CONSERVATION COMMISSION AGENDA

March 2, 2021 @6:00 pm
Virtual Meeting

Lot # 233
 47,495 sq. ft.
 1.0903 acres
 R=0.47

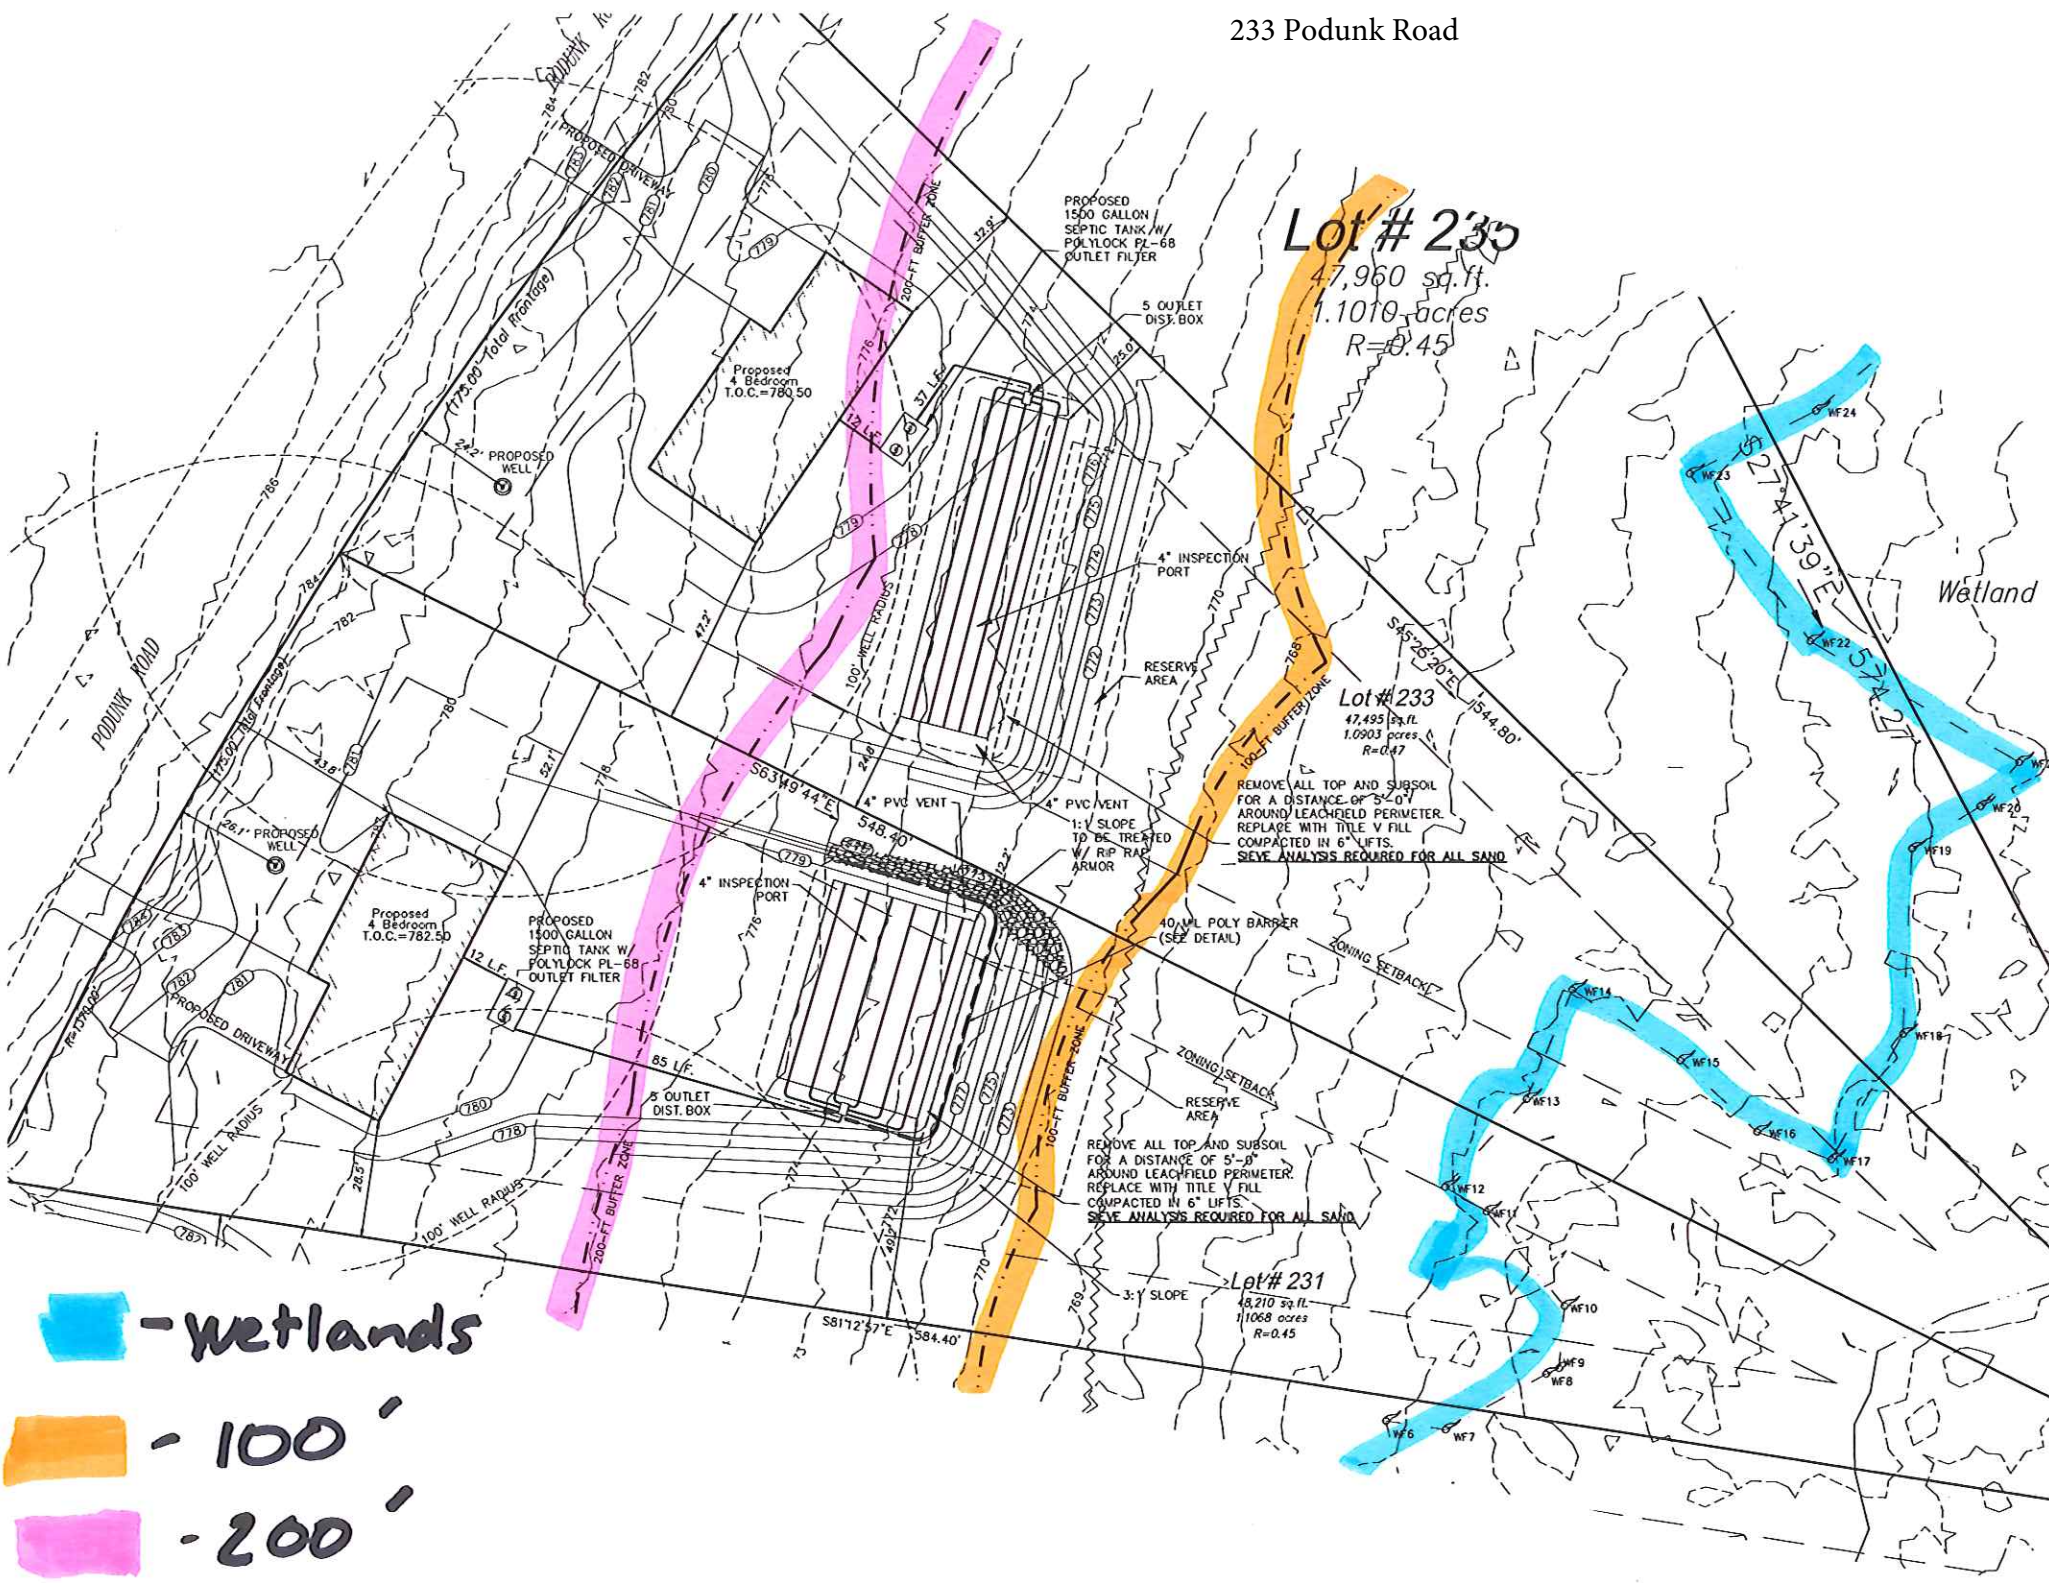
- All work is proposed within an existing agricultural field.
 - No work is proposed within the 100-foot state WPA buffer zone. Construction of the septic system is the only work proposed within the 200-foot local buffer zone.

- Staff Recommendations:
 - Sedimentation controls are included at the limit of grading as shown on the plan. The limit of grading shall serve as the limit of work.

AREAS 1, 2 & 6

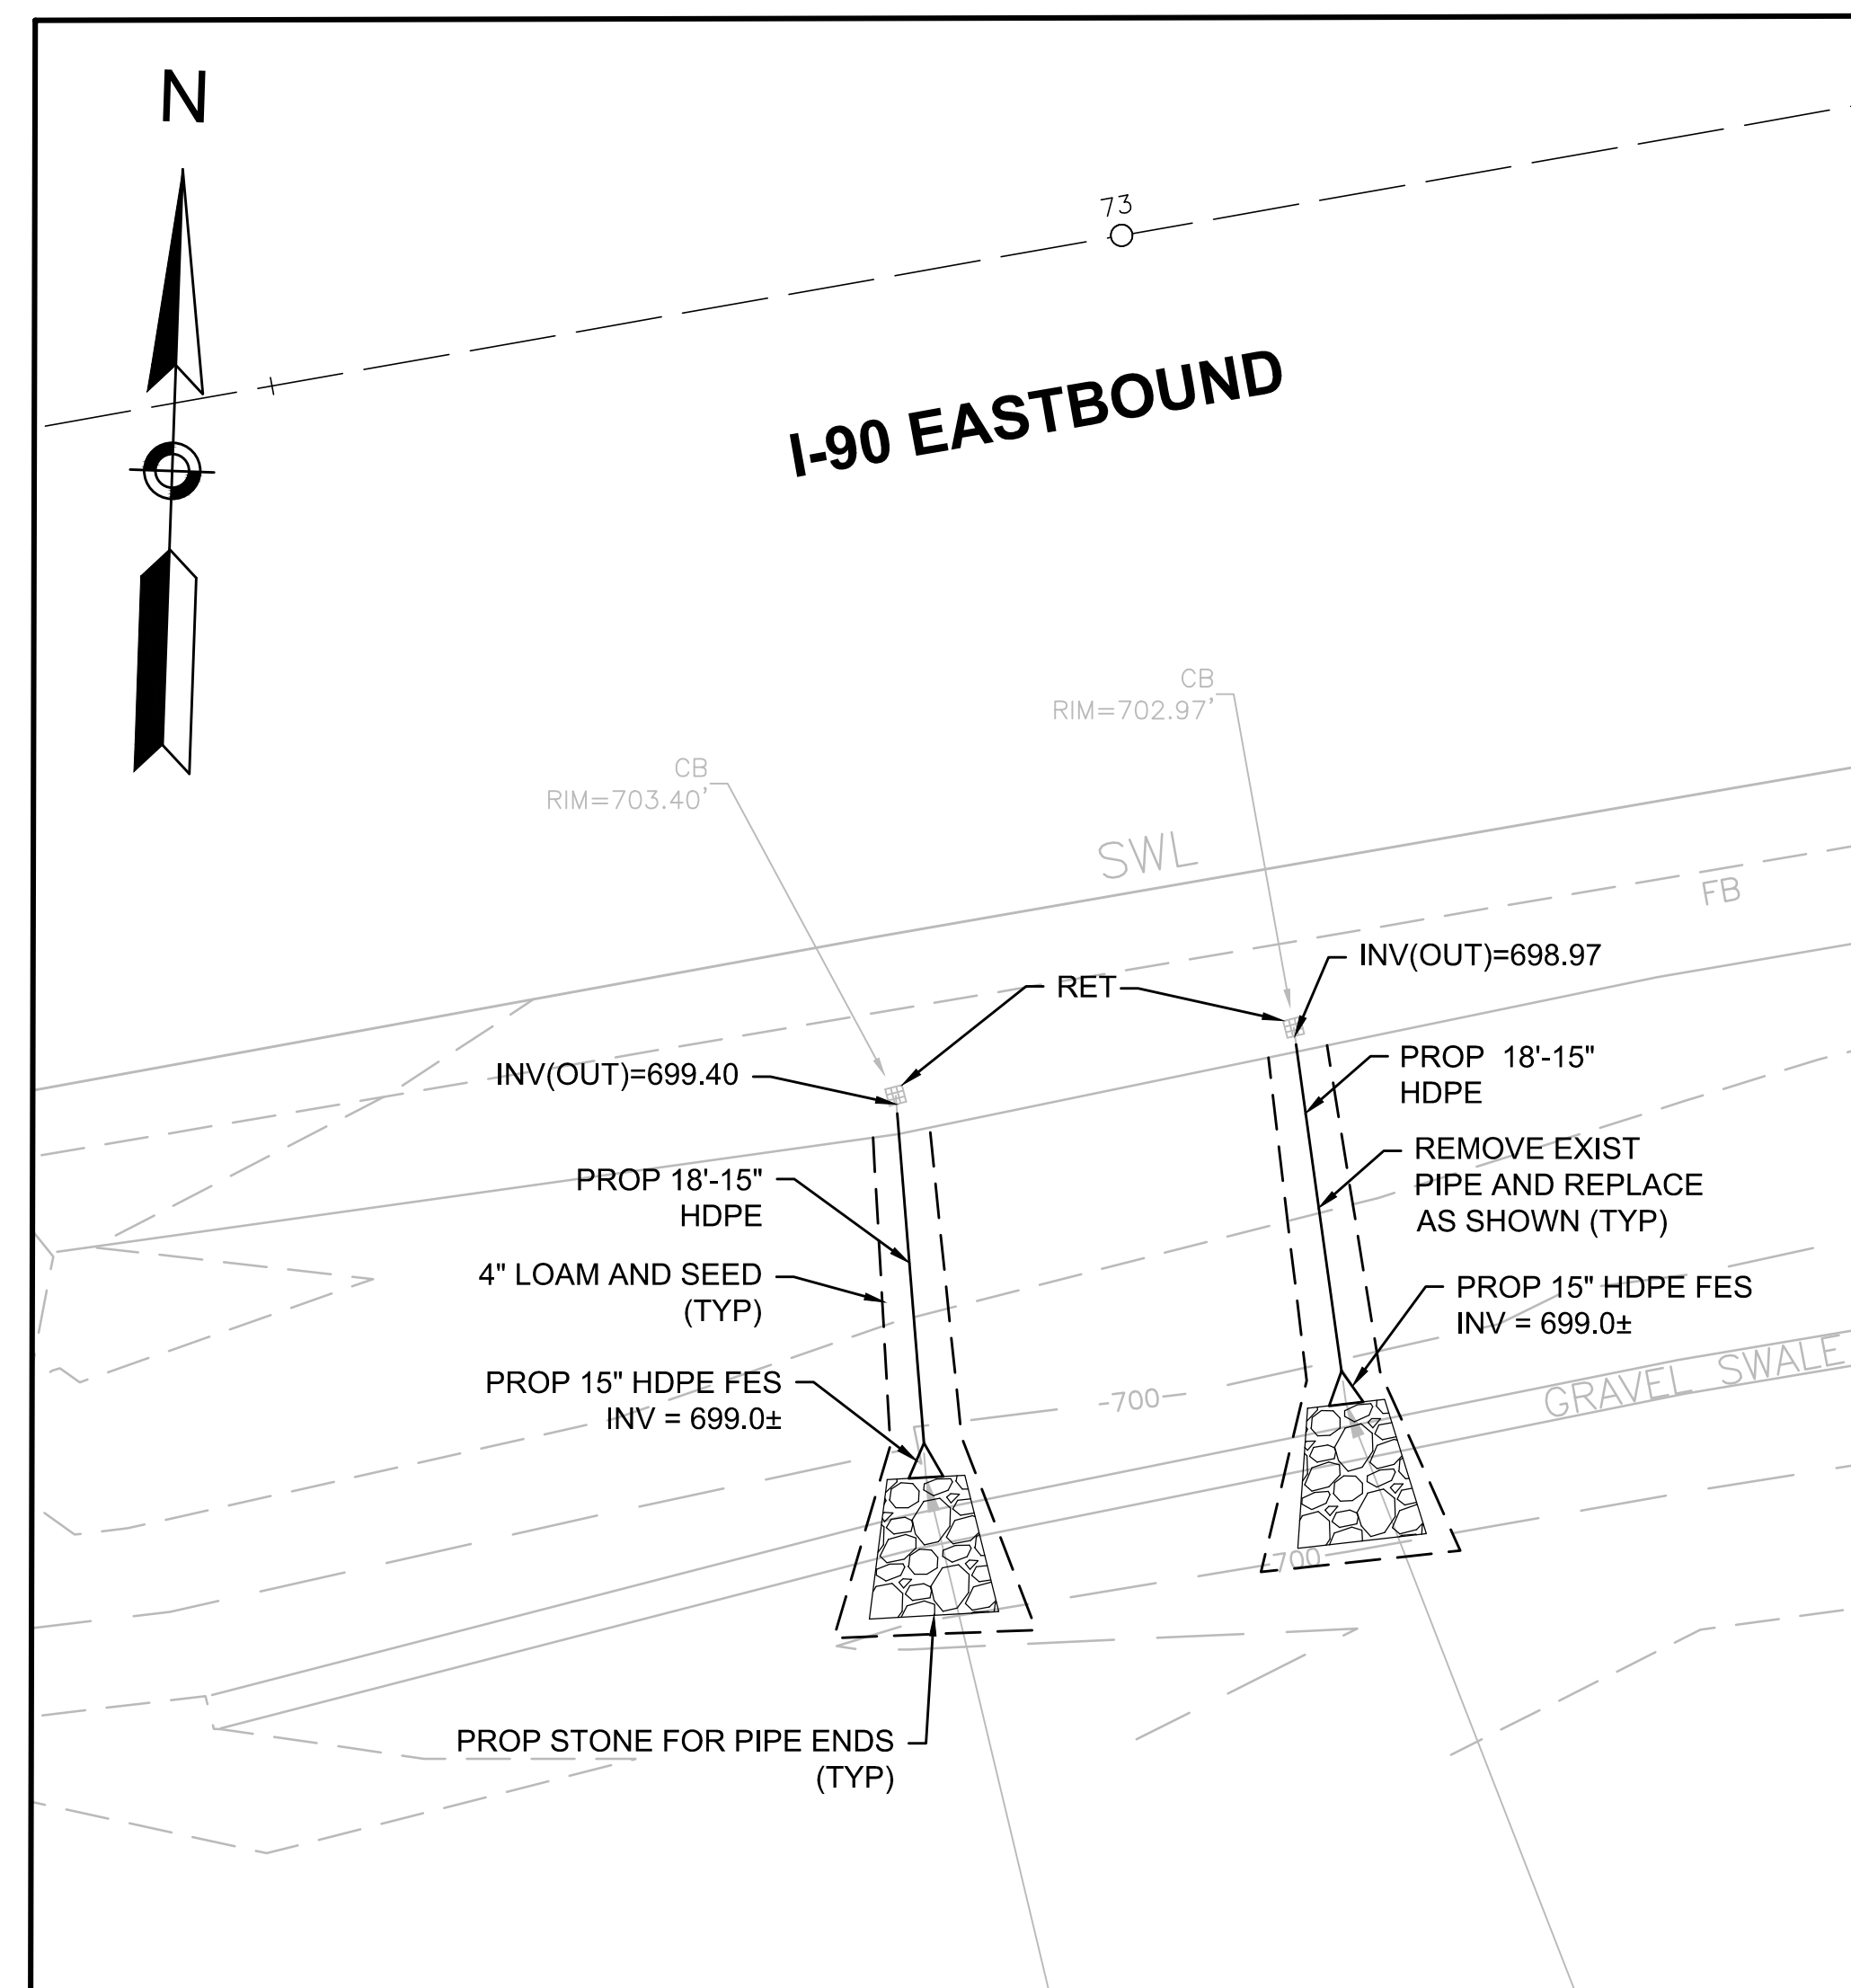
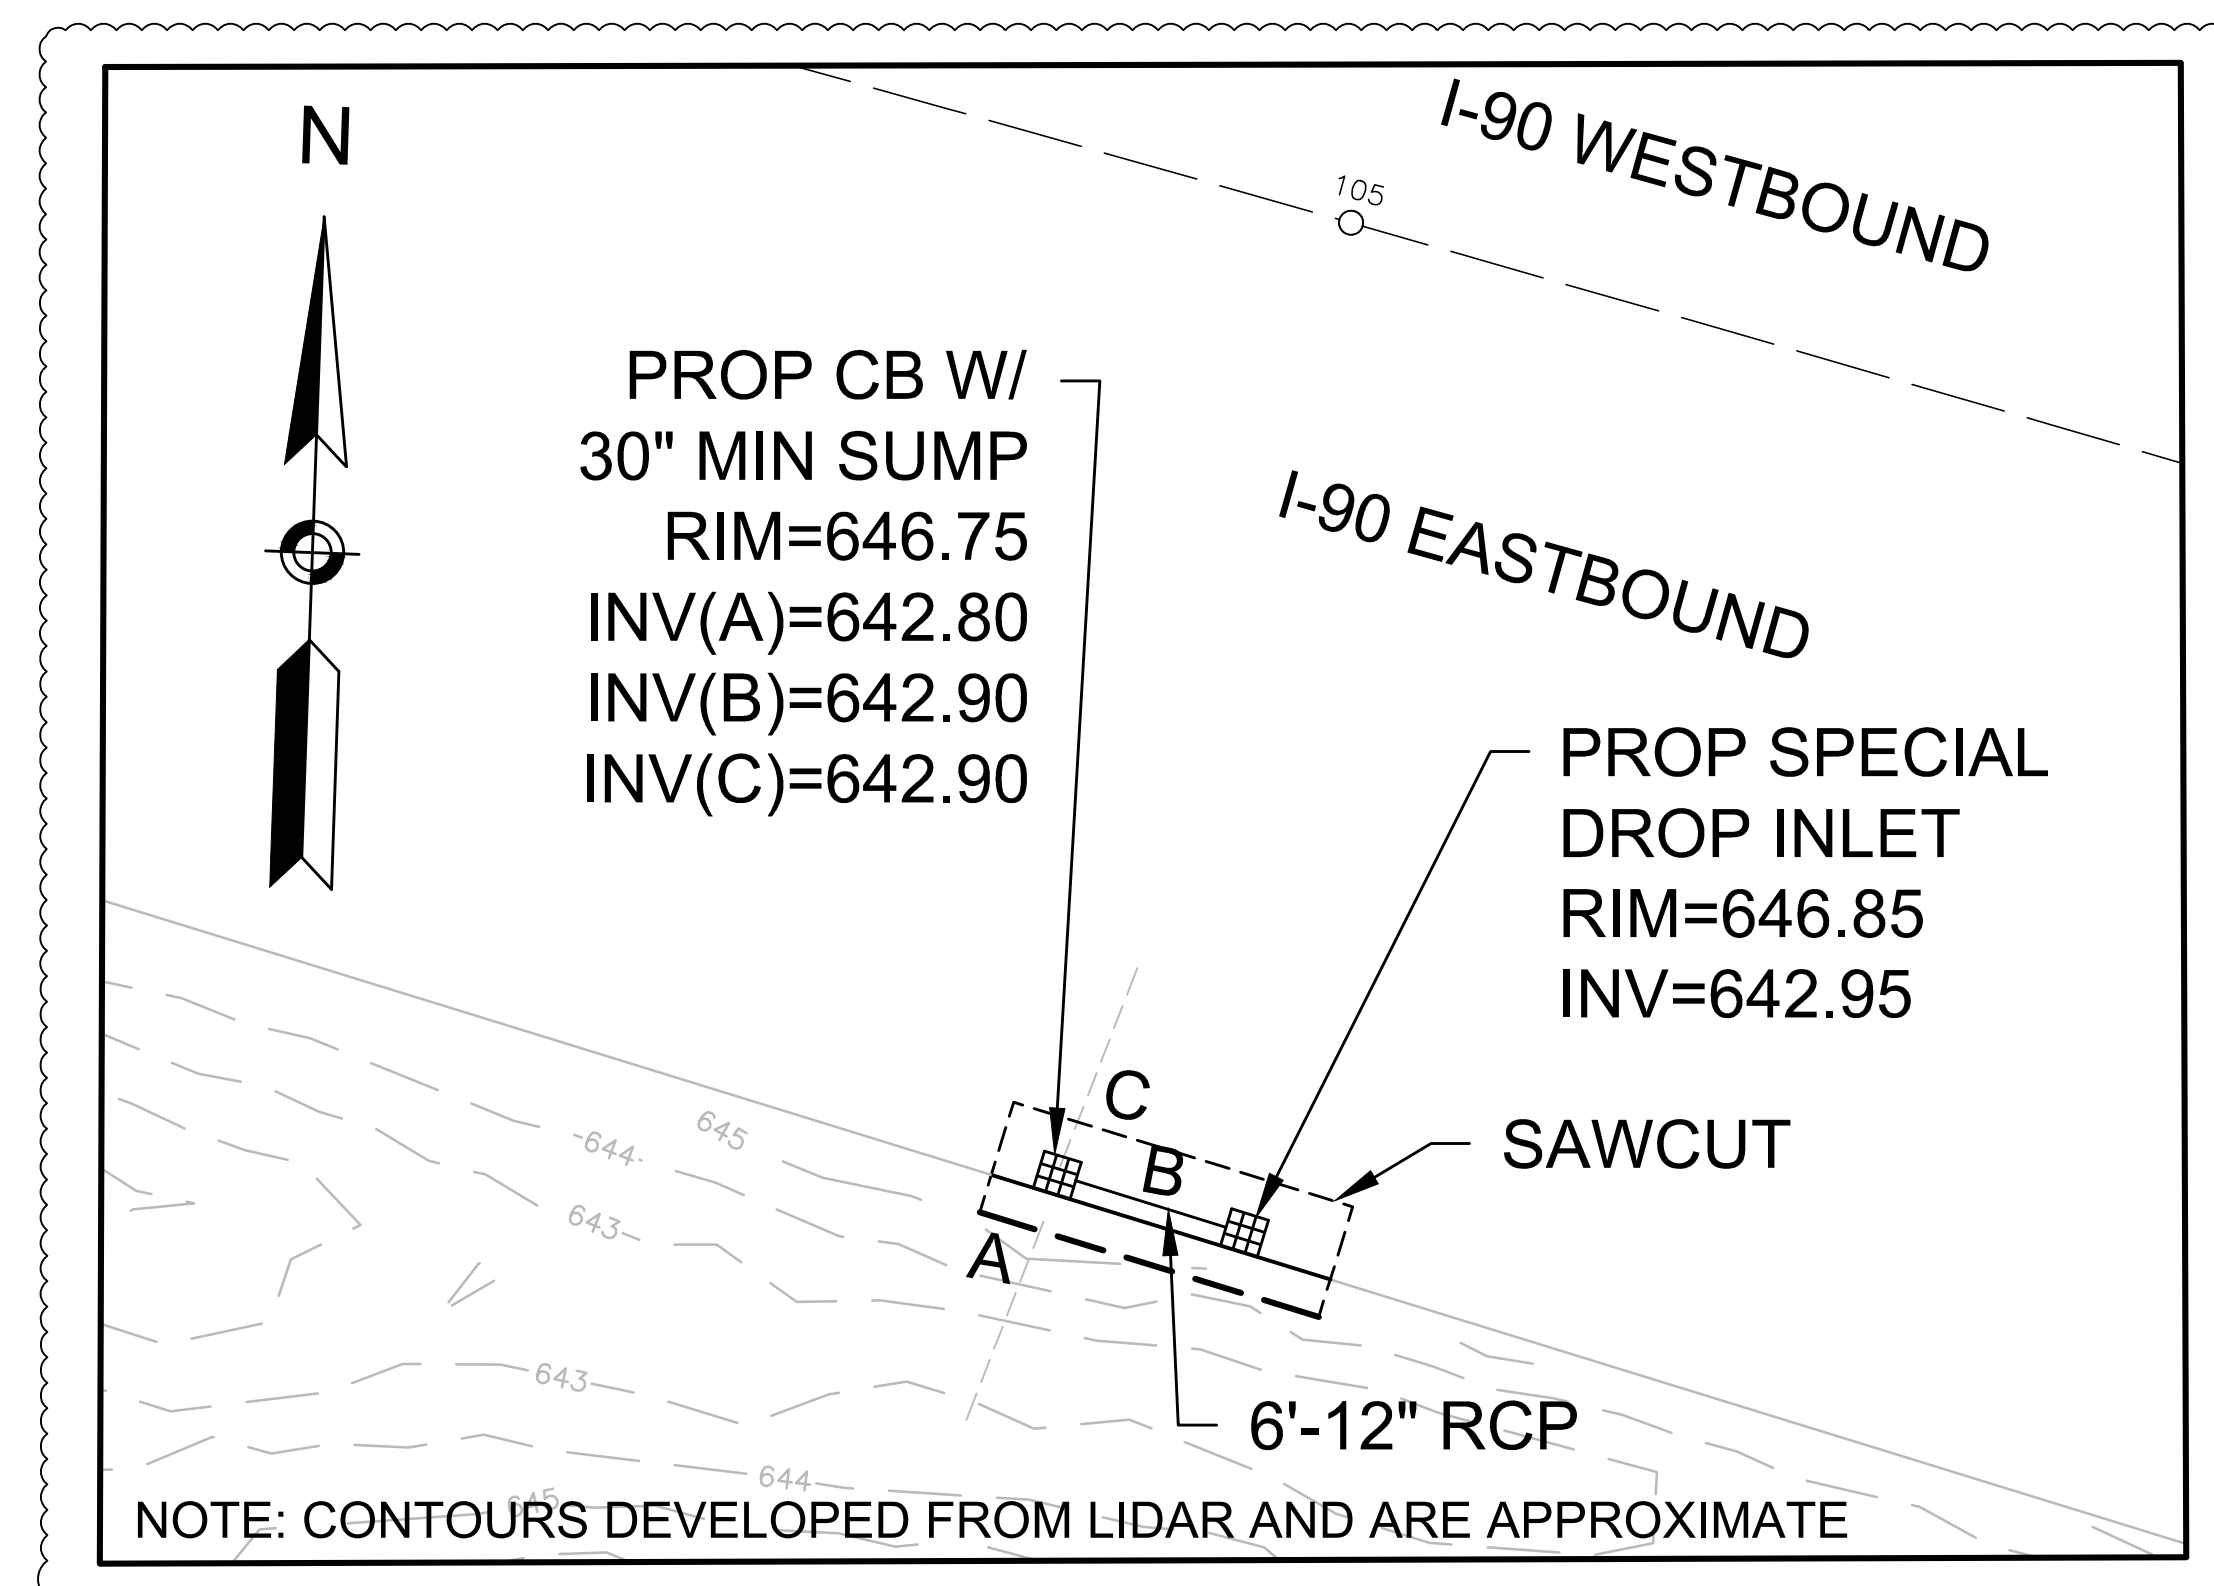
- Staff Notes:
 - The plan includes: full repair of the eastern swale, Area 5 on the plan, as requested; additional notes for work within Area 4 as requested; additional BMP improvements within Areas 2, new Area 6 and stations as shown on the plan. These BMP improvements (drop inlets, stilling wells, etc.) would appear to assist with treatment and velocity of storm-water.

- Staff spoke to CLA representatives and are pleased with modifications.
 - Staff Recommendations: Staff recommends that MA DOT provide a timeframe for implementation of the project changes. Will this affect the timeline provided? Approve plan as shown w/ the following notes. Staff recommends that all disturbed areas are seeded (w/ native seed mixes) and remain protect with erosion controls until the areas are stabilized. SCC shall be notified when work within each area is completed. Completed work should be reviewed by designing engineer and letter of substantial compliance (detailing any project variations) submitted at end of the project. Residents near Area 5 should be notified of work by DOT. Trees should be added to screen the residence near Area 5. Follow up monitoring of the implemented work should be conducted to ensure the improvements are functioning as designed. EO shall not be released until monitoring and documentation of completed and functioning project.
